REMARKS

APPENDIX TO AMENDMENT IN RESPONSE TO FIRST OFFICE ACTION WITH AMENDED TEXT MARKED TO SHOW CHANGES

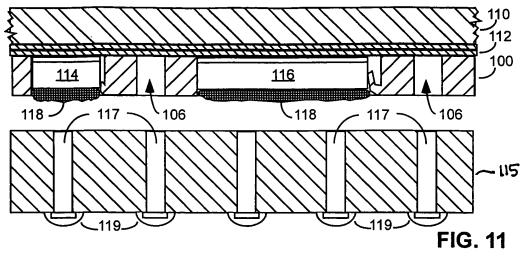
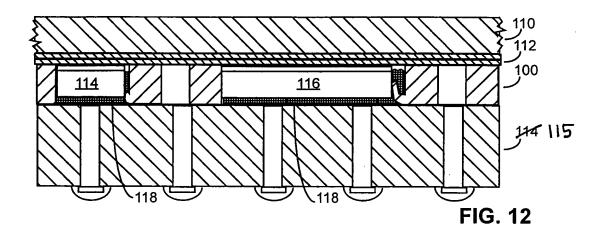
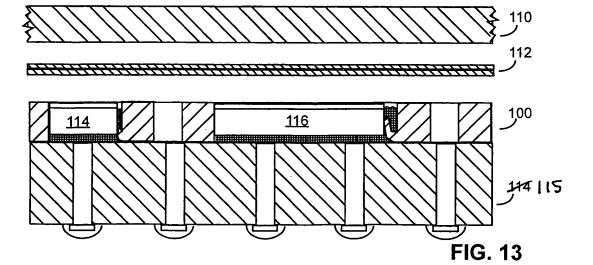
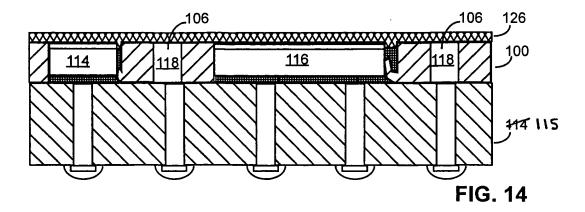
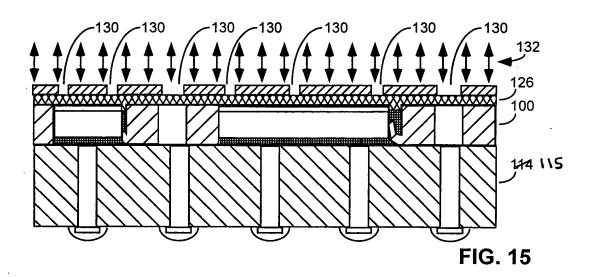
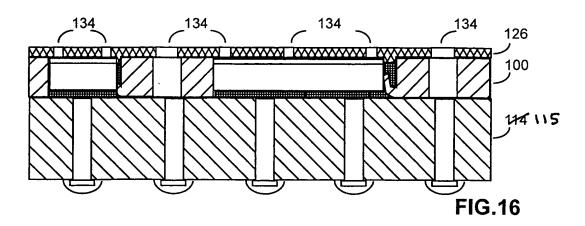
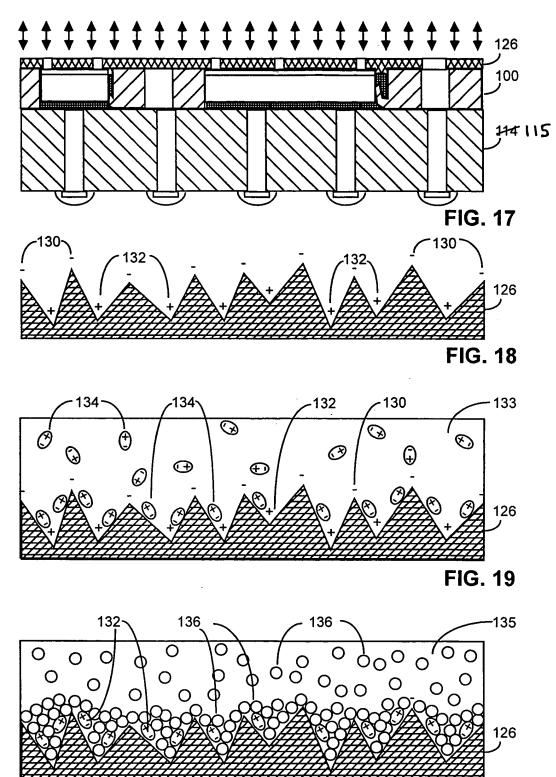
The Office Action objected to the drawings because the reference character "114" has been used to designate both "chip 114" and "substrate 114." In response, corrections have been made to FIGS. 11-17, 21-26, and 29-38 to label the

change to the numeral for the substrate from 114 to 115 where numeral 114 occurred for the substrate or to add numeral 115 where the substrate was not labeled. In FIG. 39 the numeral 114A has been replaced with 115A. Applicants enclose herewith a version of the drawings, indicating the changes in red and a complete new set of corrected formal drawings, all without the addition of any new matter.
